Service Bulletin

Subject: **Gear selector connecting rod screw**

Product: **RUSH**

Service Bulletin n° 275 - Gear selector connecting rod screw RUSH

Identification of the part:

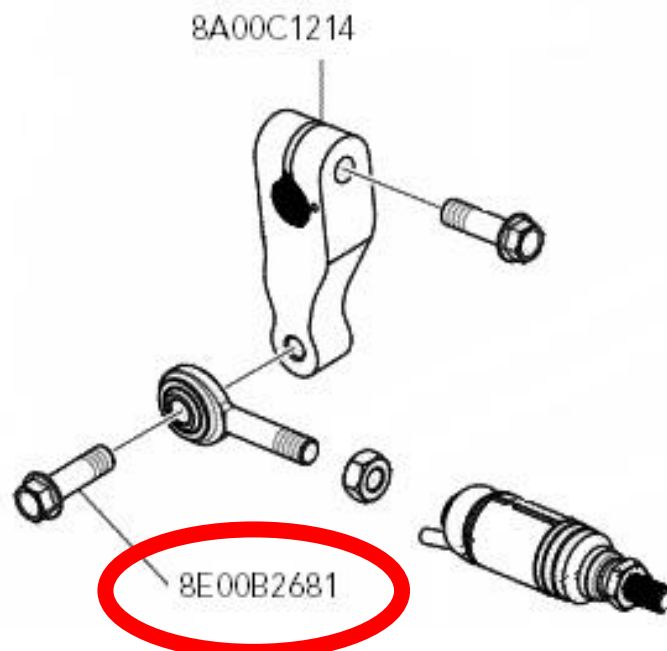
As part of the process of continuous improvement of the quality of our products, we would like to inform you about the new tightening of the gear selector fixing screw, having found that on some vehicles the fixing screw has an incorrect torque that could cause loosening and consequent malfunction or damage.

1. Locate the fixing screw of the gearbox connecting rod cod. 8A00C1214; the screw must be reused.
2. Tighten the M6X20 fixing screw cod. 8E00B2681 applying the torque of **10 Nm**
